RE: **Grants Reclamation Project – DP-200 Renewal – Response to September 12, 2000 NMED Letter Transmitting Comments / Questions on Renewal Application**

**HOMESTAKE MINING COMPANY
Grants Reclamation Project
DP-200 Renewal**

**RESPONSES TO
NEW MEXICO ENVIRONMENT DEPARTMENT
REGARDING QUESTIONS / COMMENTS ON DP-200
RENEWAL APPLICATION
PER
NMED LETTER DATED SEPTEMBER 12, 2000**

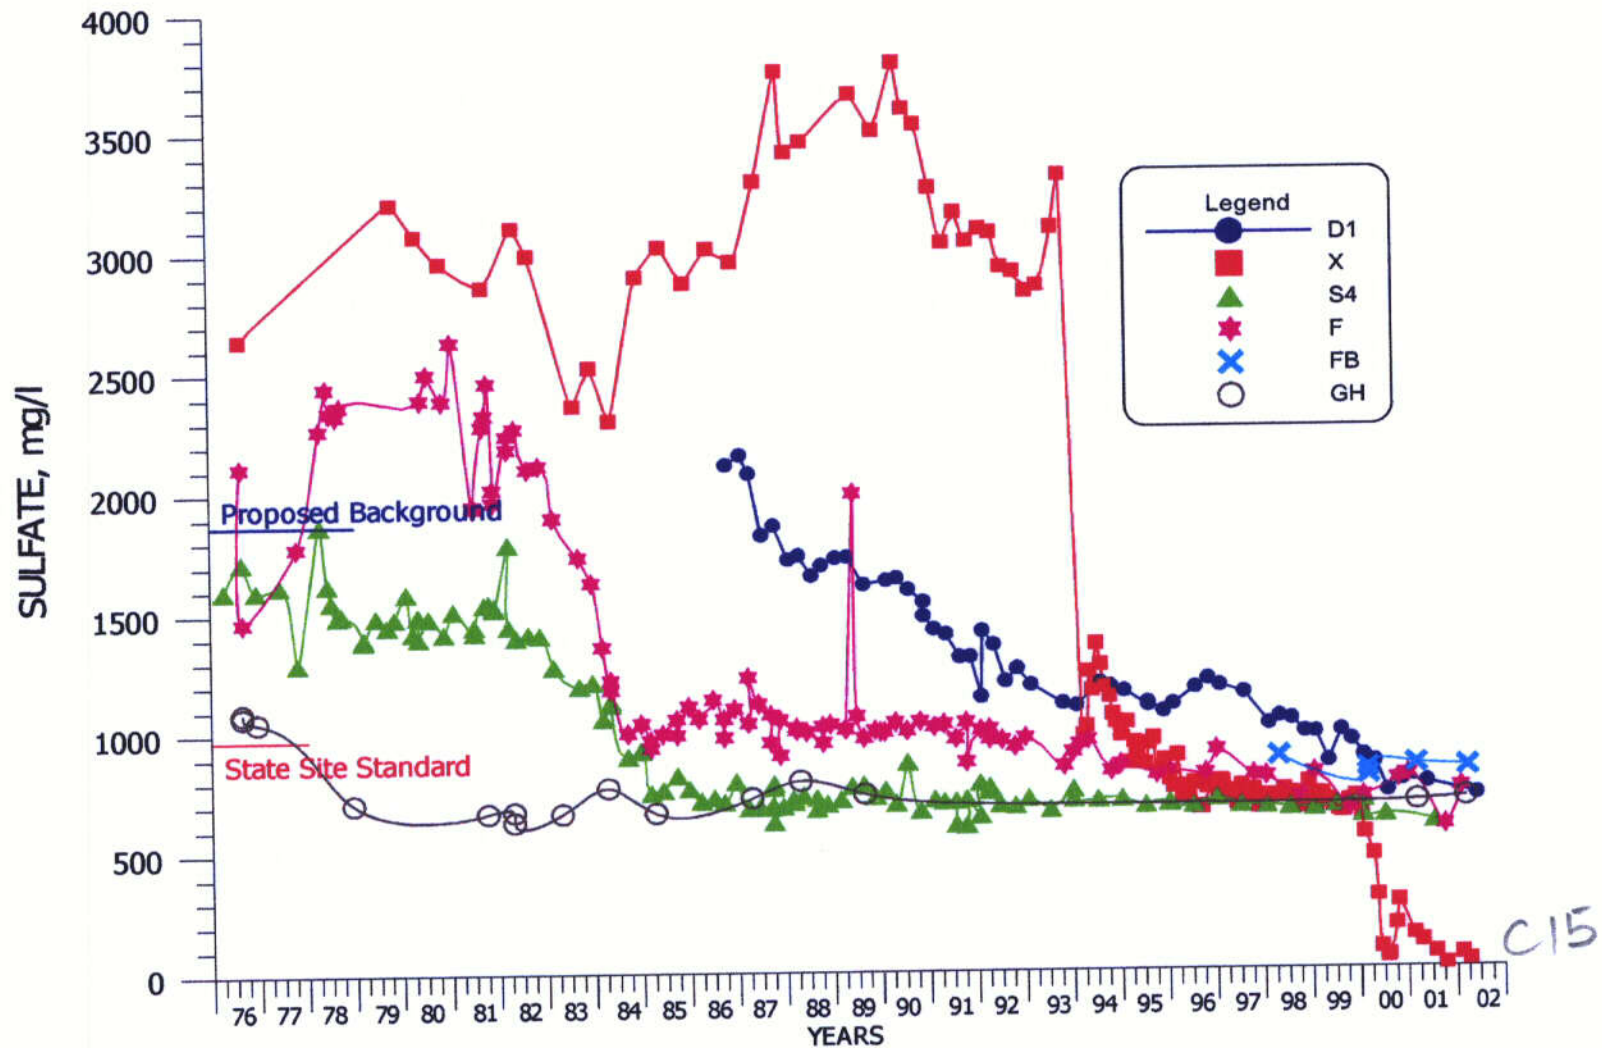
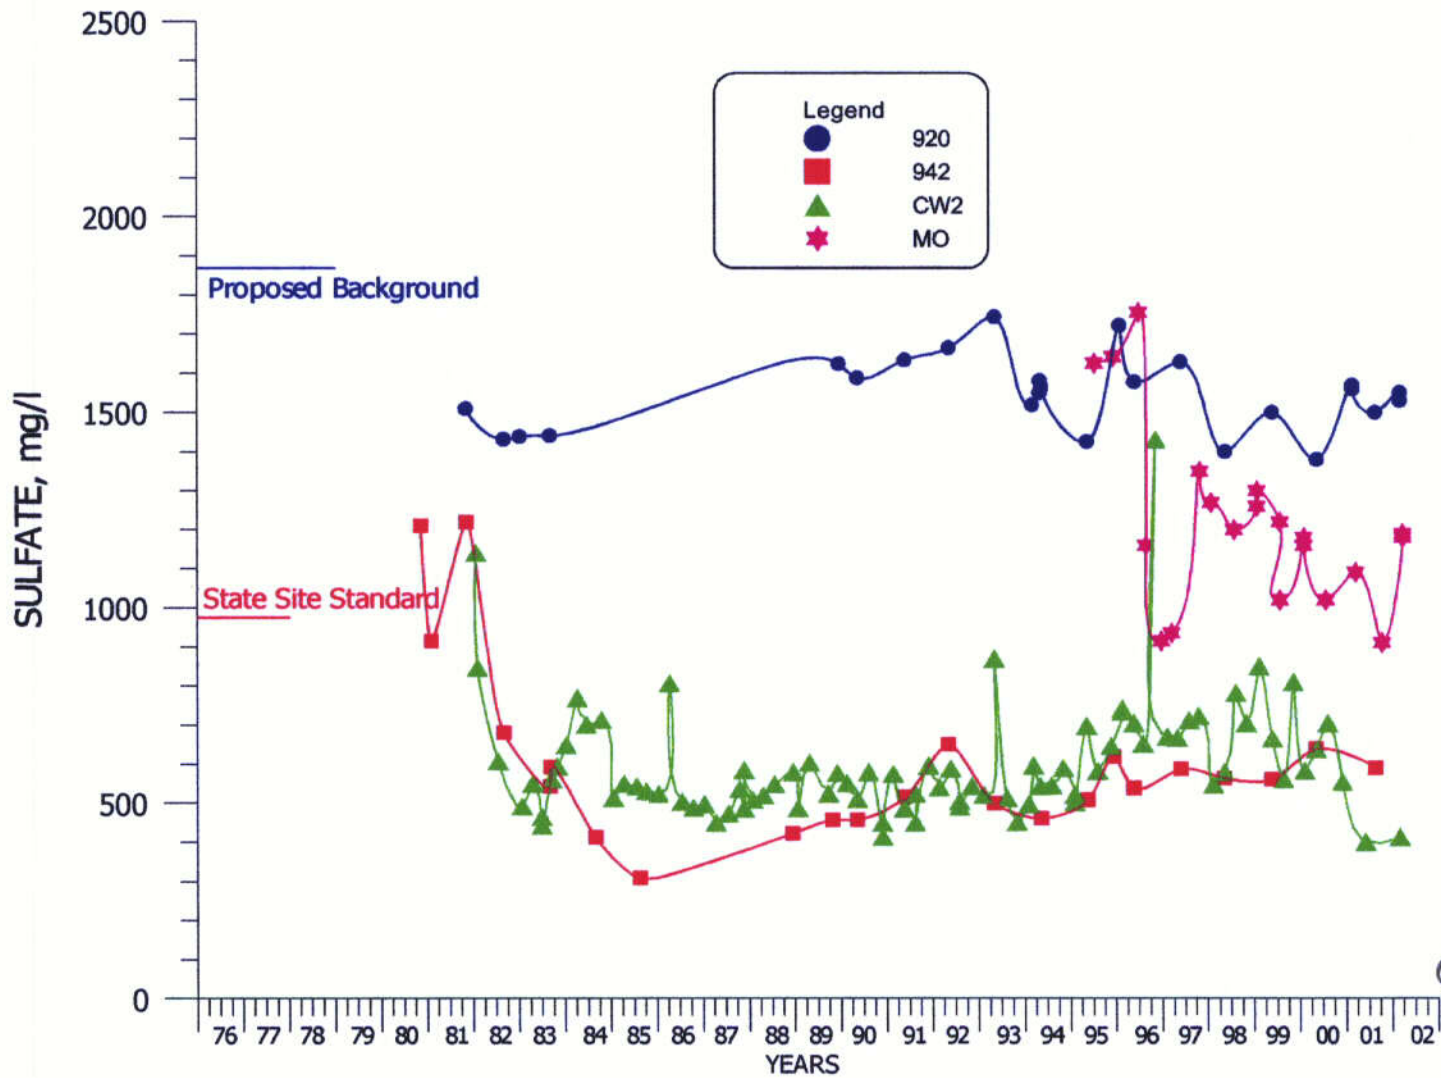
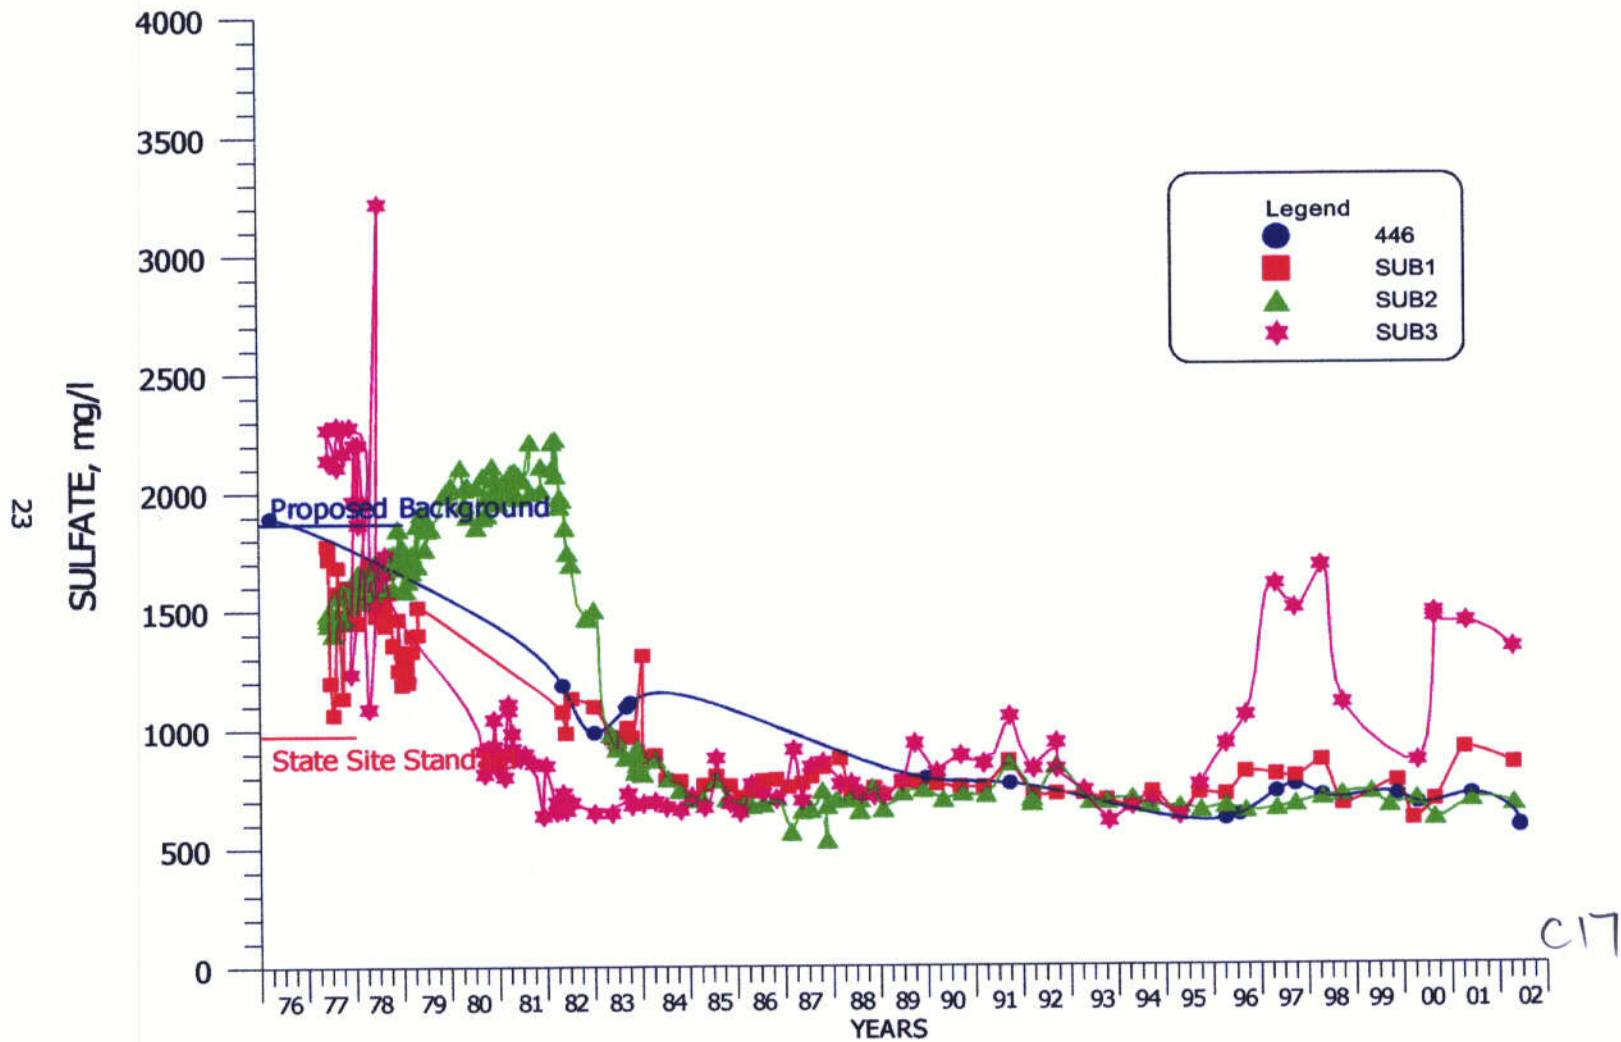
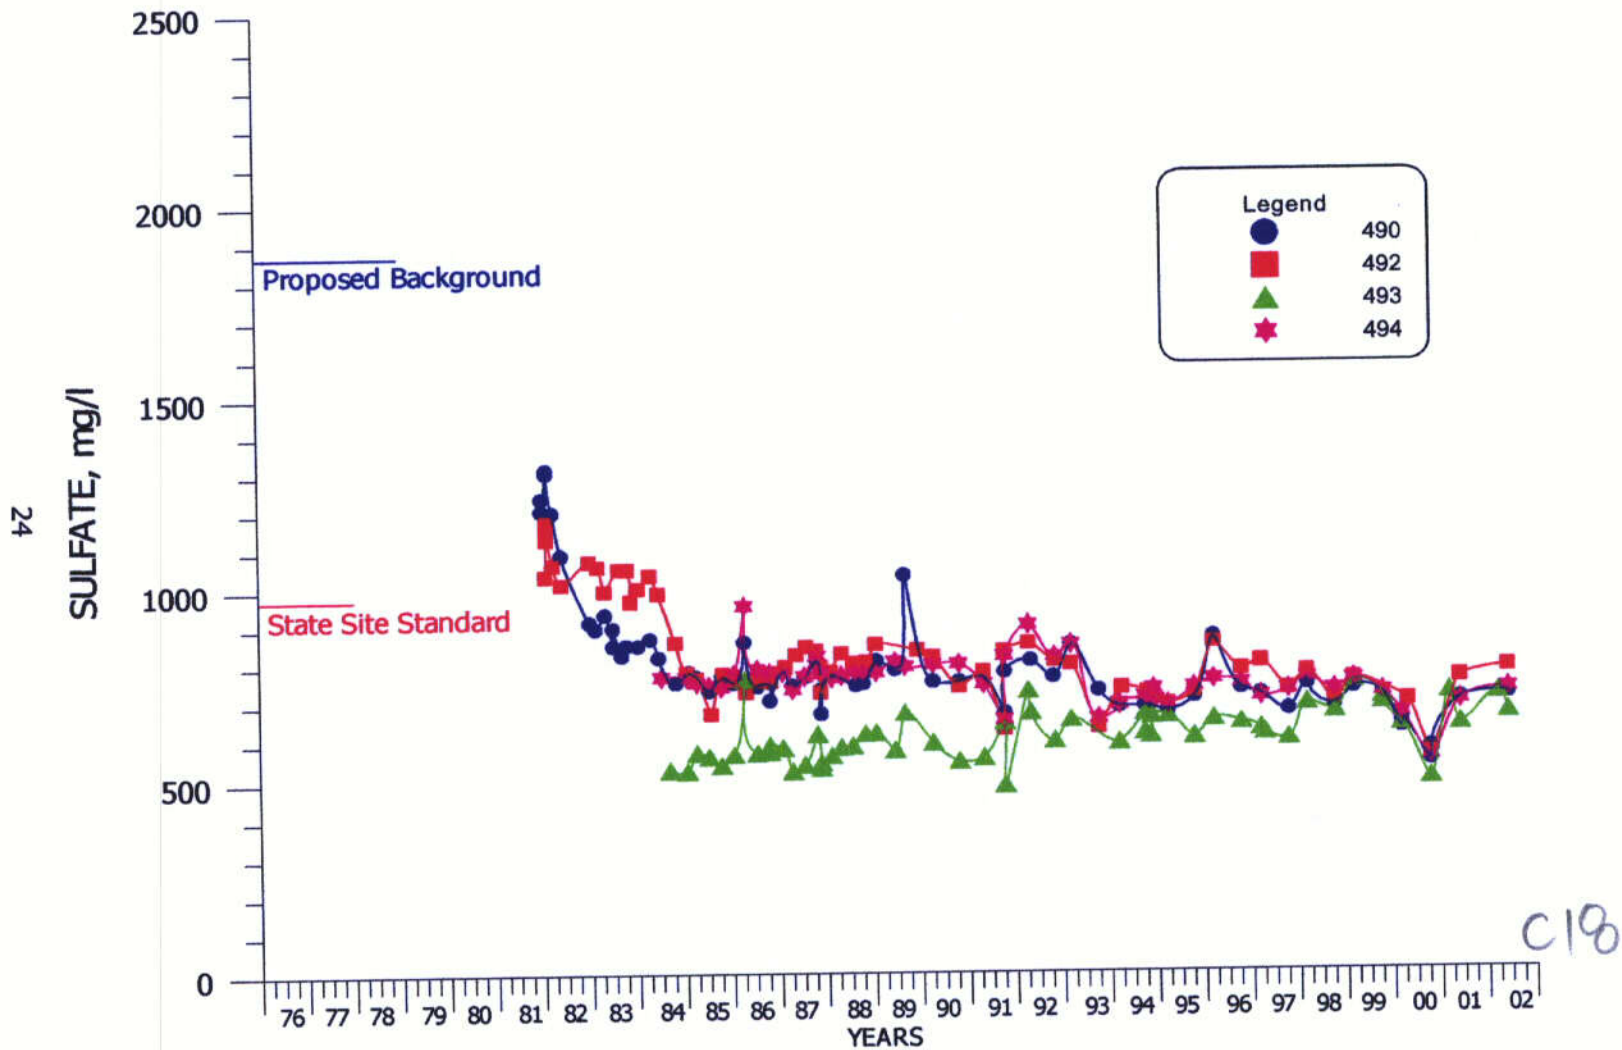
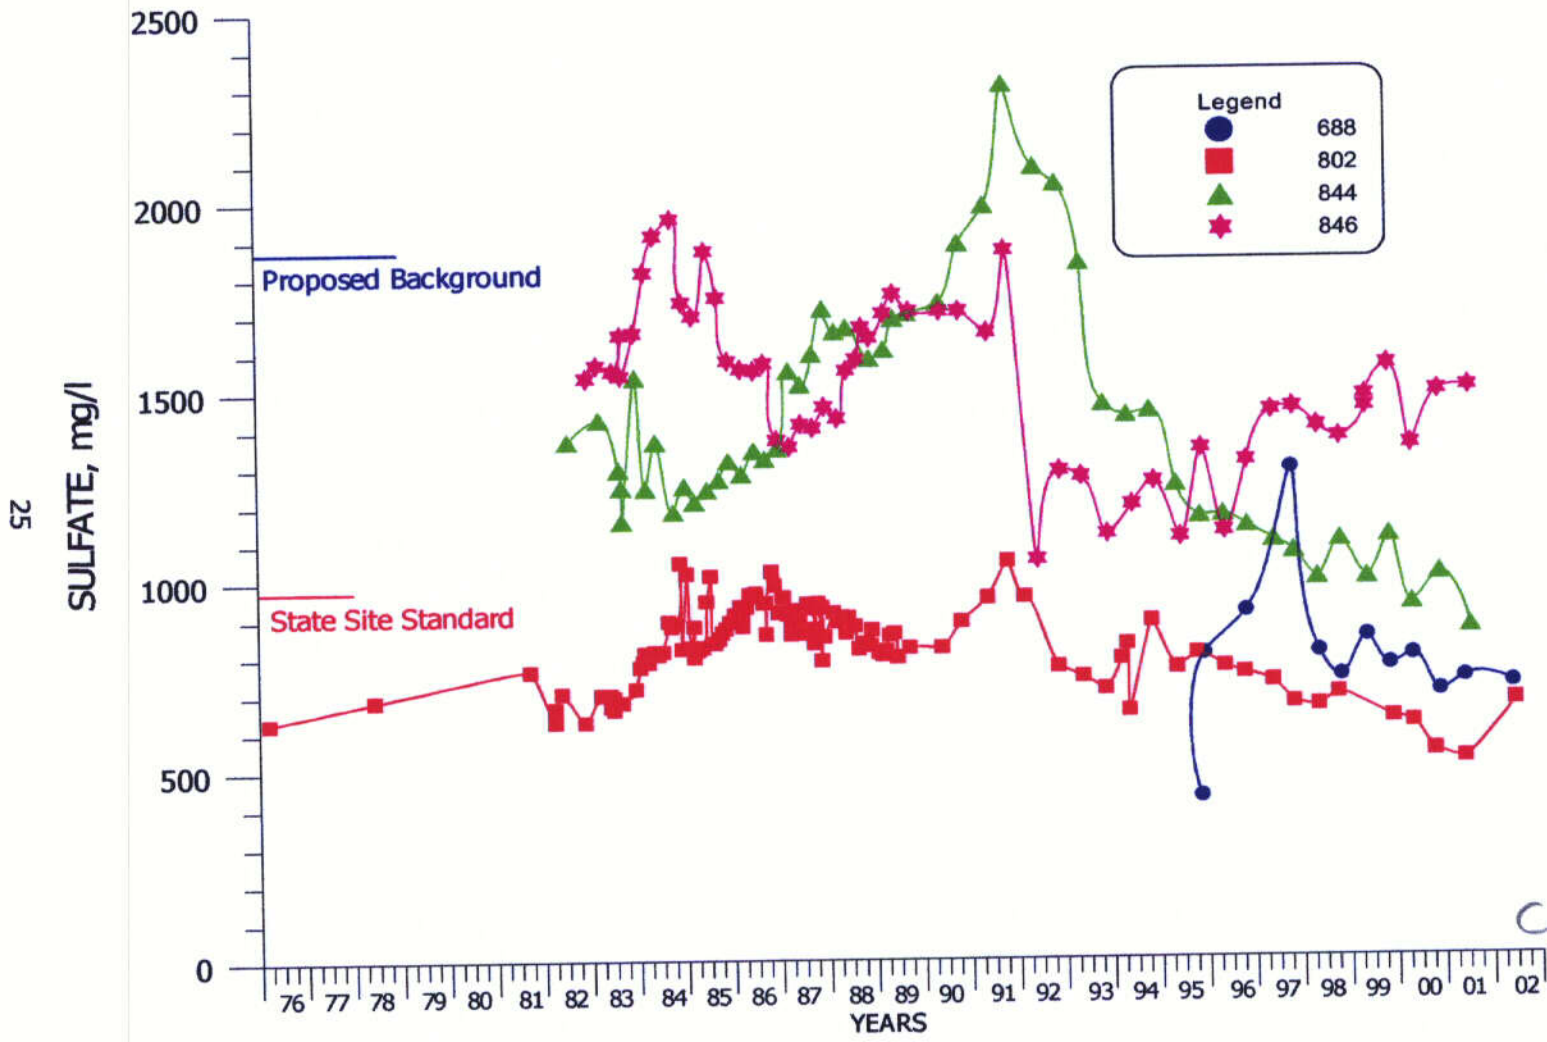
Comment: III.1.B. Graphs of Water-quality Data for the Table 2 Wells

Response: Plots for the routine monitoring wells from Table 2 of the NRC license are presented for sulfate, TDS, chloride, uranium, selenium, molybdenum and nitrate concentrations as Figures 15 through 49. The first group of wells for each of these constituents are presented for the three POC wells (Wells D1, X and S4) and

the initial figure also includes on site wells (Wells F, FB and GH). The following tabulation lists the figure numbers for each of the constituents:

CONSTITUENT	FIGURE NUMBER
SO4	15 – 19
TDS	20 – 24
Cl	25 – 29
U	30 – 34
Se	35 – 39
Mo	40 – 44
NO3	45 – 49

A few different vertical scales were required due to the large variations in parameter concentrations. The present State standard and the proposed background concentrations are presented on the plots.
